Model-5 1934 IF 460 K.C

Model-10

1933-34 IF 260 KC.

DATA SHEET

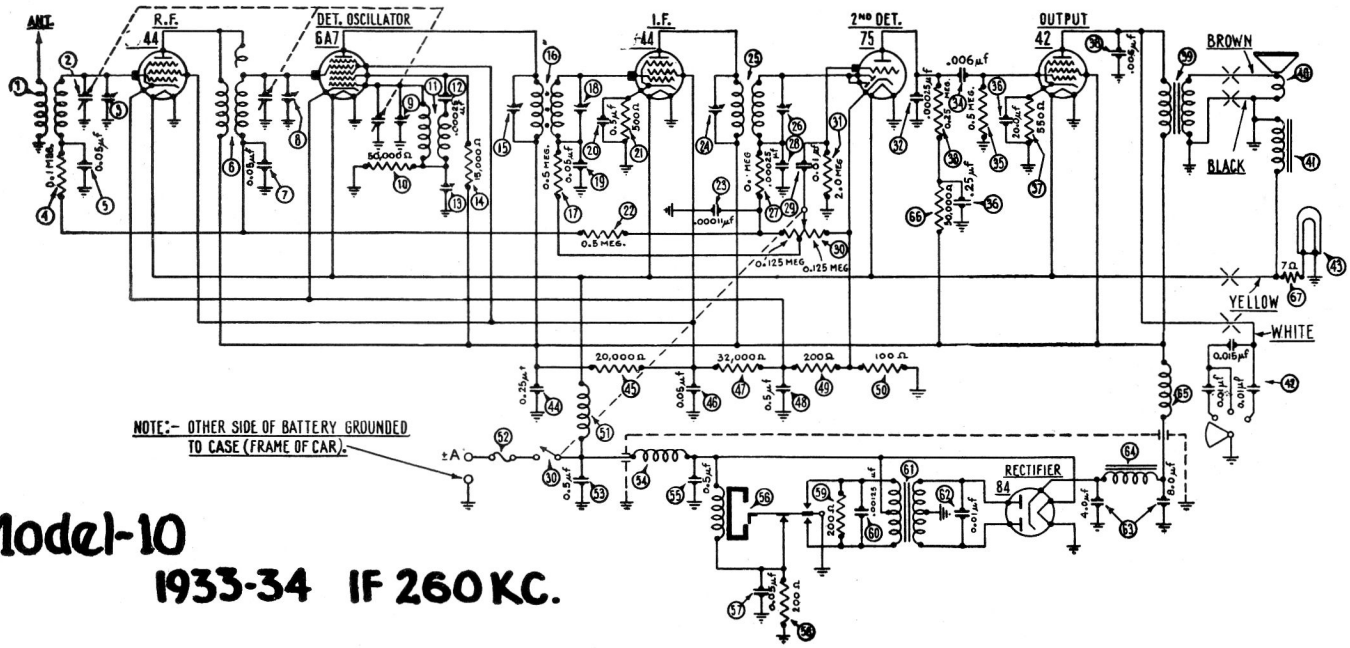
NOTE.—The first condensers (30-4017) were made up having five sections. The .1 mfd. section has now been removed from the can and this section replaced with a .006 mfd. condenser (Part No. 30-1001). This condenser is located in the chassis adjacent to the grid terminal of the 41 tube socket.
